PART 21 - ISSUES IDENTIFIED WITH THE ENTERPRISE DIESEL ENGINE SUBCOVER

Report No. 10CFR21-0114  
Rev. 0: 12/28/16

**10CFR21 REPORTING OF DEFECTS  
AND NON-COMPLIANCE**

COMPONENT: Subcover Assembly, P/N 1A-7846

**Item #1:**

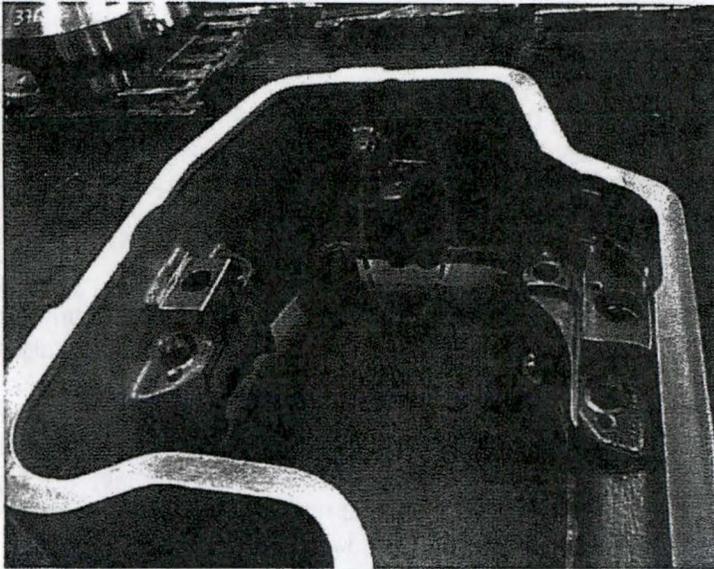
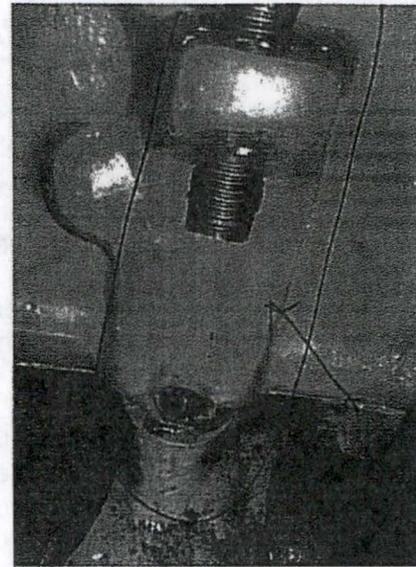
Engine Systems Inc. (ESI) began a 10CFR21 evaluation on November 18, 2016 upon notification of an issue with a subcover assembly at Perry Nuclear Plant. Attempts to install the subcover on their Enterprise diesel engine revealed two issues that prevented successful installation. First, one of the bolt holes was not fully machined through the entire depth of the subcover. Though the bolt could be inserted into the top of its corresponding hole, it would not pass completely through. The second issue was an interference between the rocker arm shaft and its mating pedestal. It was found that incomplete machining of the pedestal prevented the shaft from sitting flat on the pedestal.

The issue regarding the inadequately drilled bolt hole would be detected during installation since it would prevent the bolt from passing through the hole. Therefore, it is determined this issue would have no impact on operability since the cover could not be installed with an incompletely drilled bolt hole.

- a) Inspect for the bolt hole (item #1). If rework is necessary, drill through to a diameter of 13/16".
- b) For the incomplete machining of the rocker arm pedestal (item #2), first remove the installed dowel which has 0.000" to 0.001" clearance. Then machine a 2" radius relief at the affected area. All other dimensions such as pedestal height shall remain unchanged.

**Item #2:**

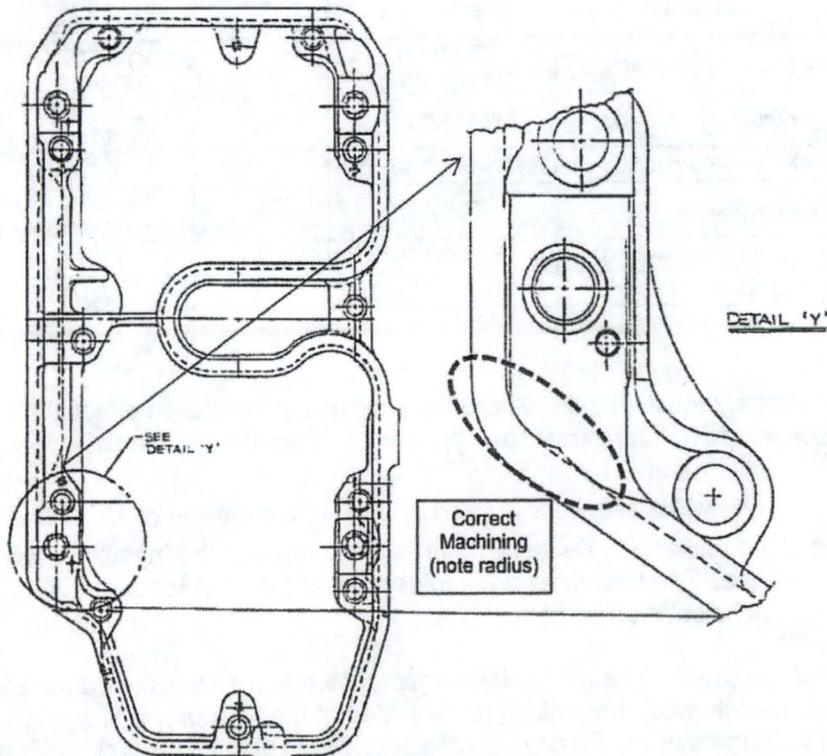
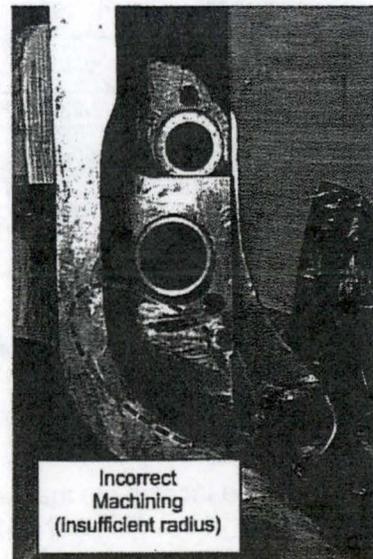
With regard to the incompletely machined pedestal, there is the potential that a customer could install the rocker arm shaft without detecting this issue. In this situation, the shaft will partially fit on the pedestal and the bolt will thread into subcover; however, the shaft will not seat fully on the pedestal. This prevents full contact with the pedestal and inhibits adequate preload throughout the bolted joint. If a customer were to install the rocker arm shaft (with mating rocker arms, pushrods, etc) onto the engine without realizing this issue, operability and durability of the engine would be compromised. This could present a substantial safety hazard.
